**Director's Report**

Project Name: Jax Kar Wash  
 Description: Planned development agreement and final site plan approval  
 Date on Agenda this packet pertains to: May 21, 2026

**RE: Jax Kar Wash- Final Site Plan/Final Engineering Plan Review – 2<sup>nd</sup> Review**

**Final Site Plan / Planned Business Review  
for  
White Lake Charter Township, Michigan**

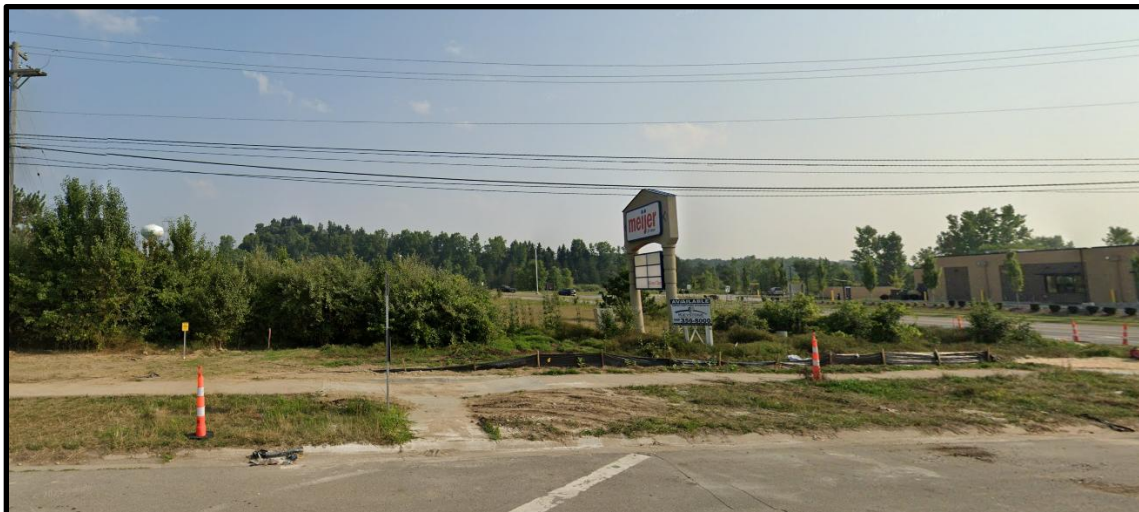
A circulation plan was provided for emergency vehicles on Sheet C-3.1. We defer to Township Public Safety to determine the feasibility of site design and hydrant placement.
